RE: Request to By-Pass Pump Leachate
Construction of MSW Phase 3
White Oak MSW Landfill
Haywood County, North Carolina
Permit # 44-07

WHITE OAK MSW LANDFILL
CONSTRUCTION DRAWINGS
MSW PHASE 3

LEACHATE BY-PASS
PUMPING

FIGURE
1

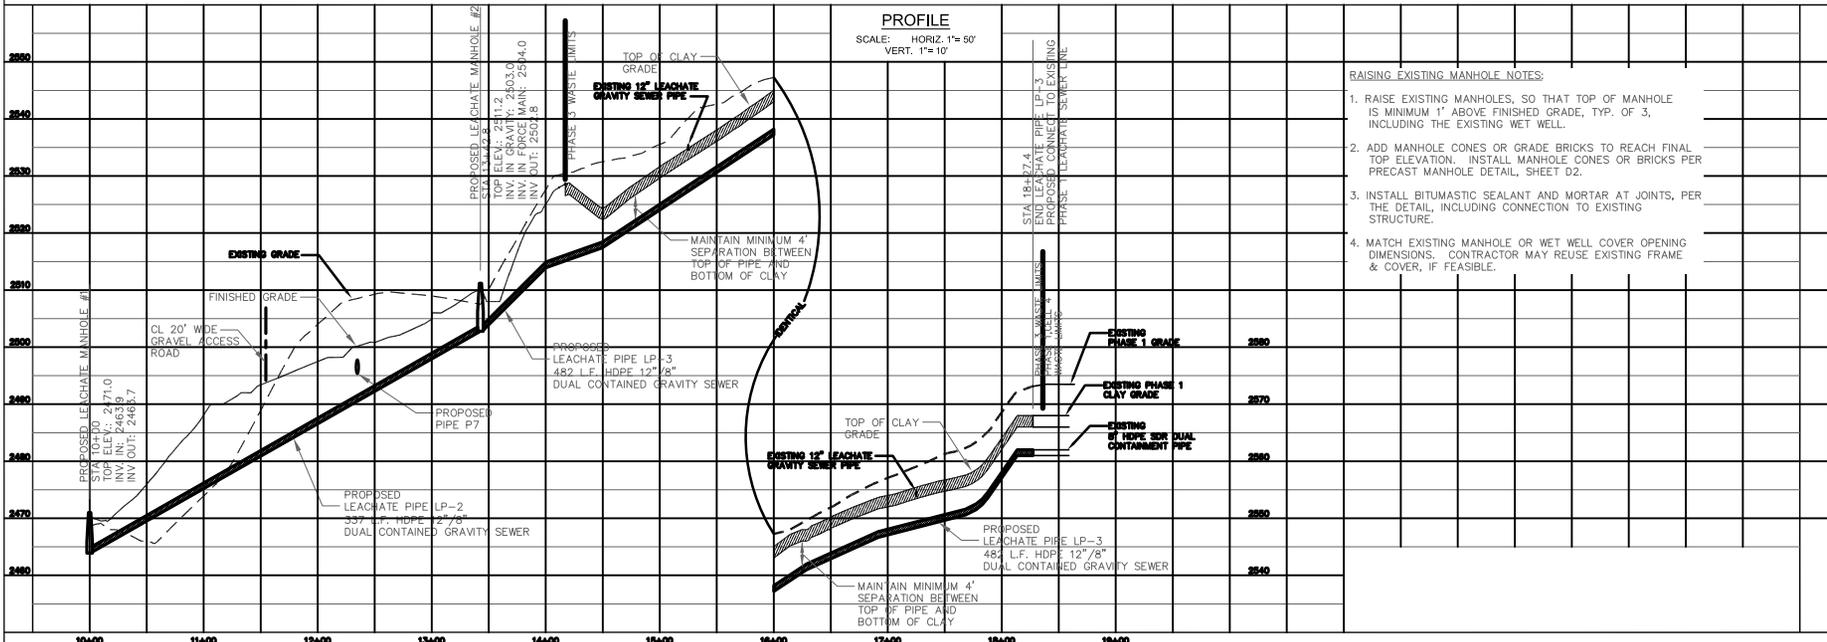
The County would like to utilize the new dual-contained leachate gravity line beneath MSW Phase 3 to pump leachate from the existing MSW Phase 2 sump area. This gravity pipe beneath MSW Phase 3 was constructed and tested in accordance with the permit drawings and project specifications. The flow would proceed through the dual-contained line and enter a manhole outside the liner edge of MSW Phase 3. From this manhole, the County requests that either a new temporary gravity line or pump and force main be utilized to convey leachate to the existing system. The Contractor will determine in the field the best option for removing leachate from this manhole. This piping (for both the gravity line and force main) will consist of single-wall piping, and will operate only until the Phase 2 system described below is installed, or until the remainder of the dual-contained gravity sewer is installed per the permitted drawings. This

measure will greatly assist the County in handling leachate from the existing MSW Phase 2 sump area. See Figure 1 for the location of the proposed single-wall gravity pipe/force main.
